**A REPORT TO THE AUTHORITY**  
**Pursuant to Paragraph 2 of Condition C14 of the**  
**Transmission Licence**

**Consequential Grid Code changes relating to CUSC**  
**Amendment Proposal 169**

Provision of Reactive Power from Power Park Modules, Large Power  
Stations and Embedded Power Stations

Consultation Paper Ref	E/09
Issue	1.0
Date of Issue	24 <sup>th</sup> November 2009
Prepared by	National Grid

### POWER PARK MODULE PERFORMANCE CHART AT THE CONNECTION POINT OR USER'S SYSTEM ENTRY POINT

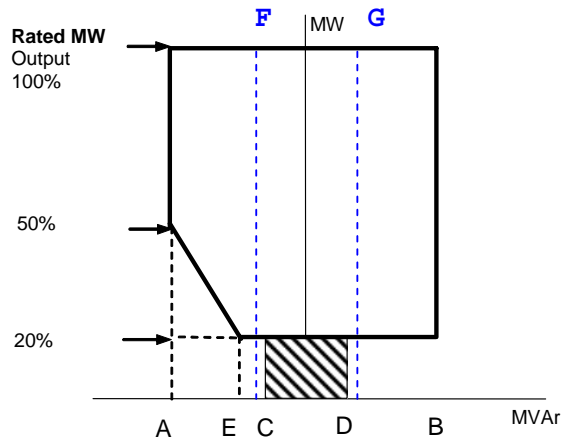
34. Under the Original, WGAA1 and WGAA3, it is proposed to add two additional lines to the Generator Performance Chart pro-forma within OC.2. A tick box has also been added so generators that are required to follow local volt conditions can communicate this. The revisions to this chart allow the generator to communicate to National Grid the range over which it is available for reactive despatch. The corresponding changes are also proposed for the Power Park Module Performance Chart which also forms part of OC2 Appendix 1.
